UNITED STATES PATENT AND TRADEMARK OFFICE

Office Action Summary	Application No. 10/084,409	Applicant(s) DORITY ET AL.
	Examiner JYOTI NAGPAUL	Art Unit 1797

DETAILED ACTION

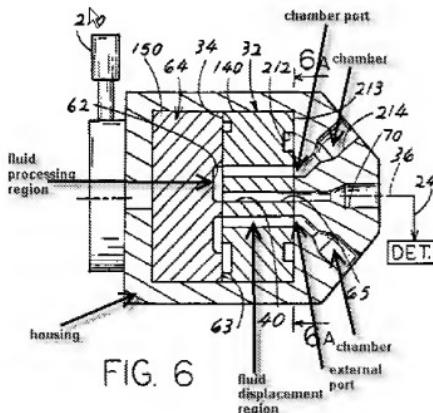
2. **Claims 1, 12, 14, 15, 27, 34, and 42-44** are rejected under 35 U.S.C. 102(b) as being anticipated by Nichols (US 6012488).

Regarding claim 1, Nichols teaches a fluid control and processing system comprising a housing (refer to figure below) having a plurality of chambers (refer to figure below). The system further comprises a valve body (32 and 64) received in the housing (refer to figure below). The valve body (32 and 64) comprising a fluid

processing region (refer to figure below) continuously coupled fluidicly to a fluid displacement region (refer to figure below). The fluid processing region is contained within a disk portion (64) of the valve body (32 and 64), and the fluid displacement region (refer to figure below) is contained substantially within a tubular portion (32) of the valve body (32 and 64) The fluid displacement region being depressurizable to draw fluid into the fluid displacement region and pressurizable to expel fluid from the fluid displacement region. The valve body (32 and 64) including a plurality of external ports (refer to figure below). The fluid processing region (refer to figure below) being fluidicly coupled with at least two of the external ports (refer to figure), the fluid displacement region being fluidicly coupled with at least one of the external ports. (Refer to Figure below) The valve body (32 and 64) being adjustable relative to a plurality of chamber ports (refer to figure below) to allow the external ports to be placed selectively in fluidic communication with the plurality of chambers. (Refer to figure below) The system further comprises at least one of the plurality of chambers is a processing chamber different from said fluid processing region. (Refer to Figure) The processing chamber (refer to figure) including a first chamber port (refer to figure) and a second chamber port (refer to figure) for selectively communicating with at least one of the external ports (refer to figure) of the valve body (32 and 64). Applicants further recite "The processing chamber contains a fluid processing material which is an enrichment material that captures a target from the fluid sample, or a trapping material that traps unwanted material from the fluid sample." This limitation is considered an intended use limitation, which does not further delineate the structure of the claimed apparatus from that of the

Regarding claim 12, the external ports are disposed on a generally planar external port surface (face of 32) of the valve body (32 and 64), and wherein the valve body (32 and 63) is rotatable around an axis and relative to the plurality of chamber ports (refer to figure above) to allow the external ports to be placed selectively in fluidic communication with the plurality of chambers. (Refer to figure above) The axis is perpendicular to the external port surface (face of 32) and the external ports being spaced from the axis by a common radius. (Refer to Figure)

Regarding claim 27, the valve body (32 and 64) is adjustable with respect to the housing (refer to figure above) to close the external port so that the fluid displacement region and the fluid processing region are fluidically isolated from the chambers (Refer to Figure above).

Regarding claims 42-44, the valve body (32 and 64) includes a crossover channel (62), the valve body being adjustable with respect to the housing to place the crossover channel in fluidic communication with an aspiration chamber (the chamber that leads to detector) and a source chamber (one of the chambers in the figure above leading to 62) to permit aspiration of a fluid from the source chamber through the crossover channel to the aspiration chamber. (Refer to figure above) The crossover channel (62) is a circular arc lying on a common crossover channel radius from the axis. (Refer to Figure above)
